HMC ARCHITECTS
3546 Concourse Street
Ontario, California 91764

September 10, 2010

Phase 2 - Modernization
Hunt Elementary School
San Bernardino City Unified School District
HMC #3137110-100

ADDENDUM NO. 2

Drawing No: **ESK-1**

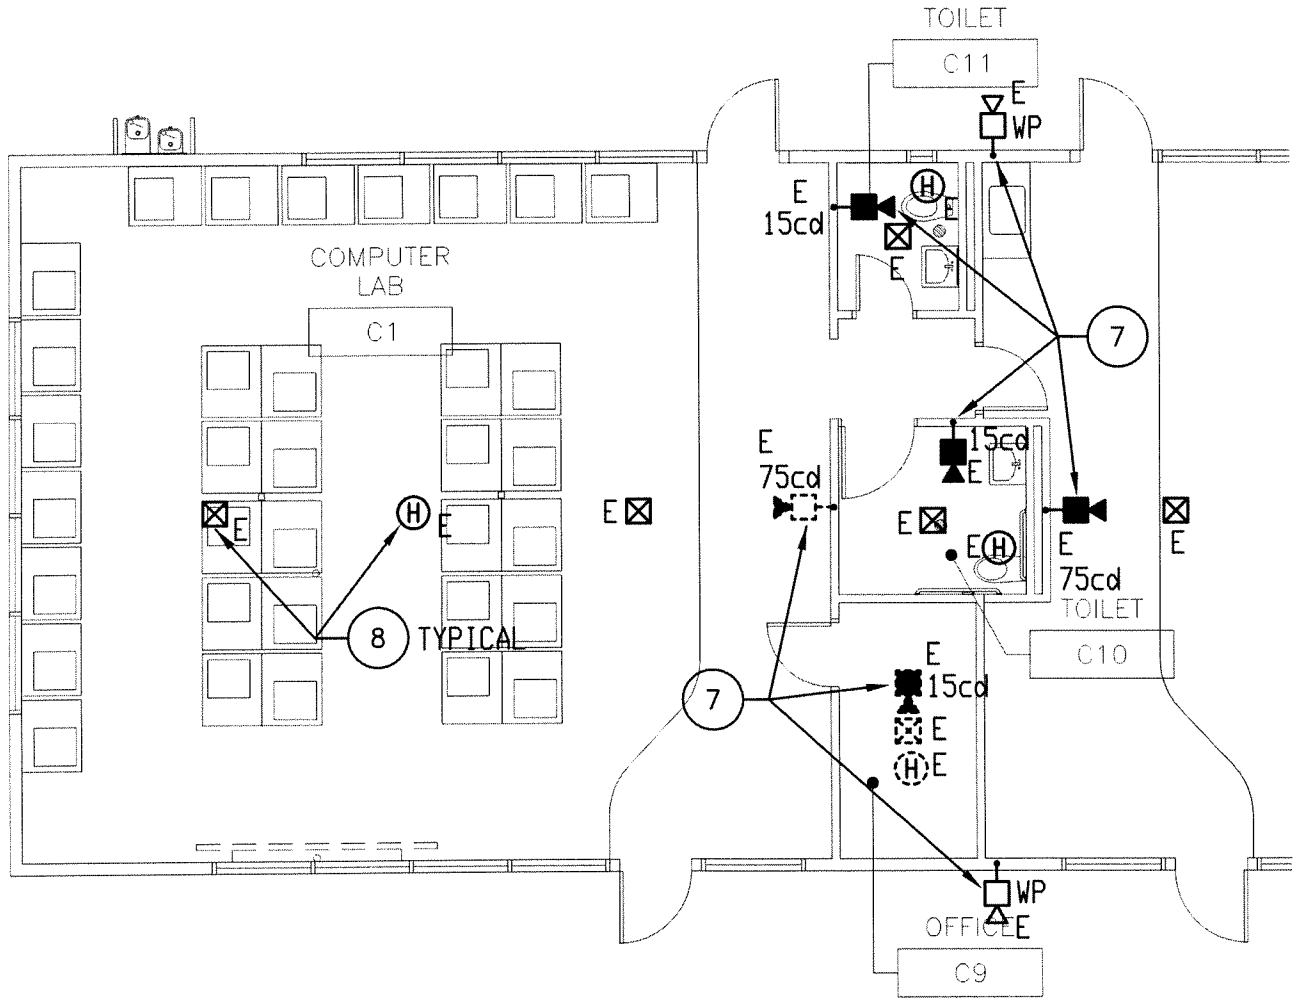
Reference Drawing ESK-1 (issued as part of Addendum No. 2)

- A. Delete power poles shown and replace with fully recessed combination power, data and communications outlet by Hubbell, System One Series.
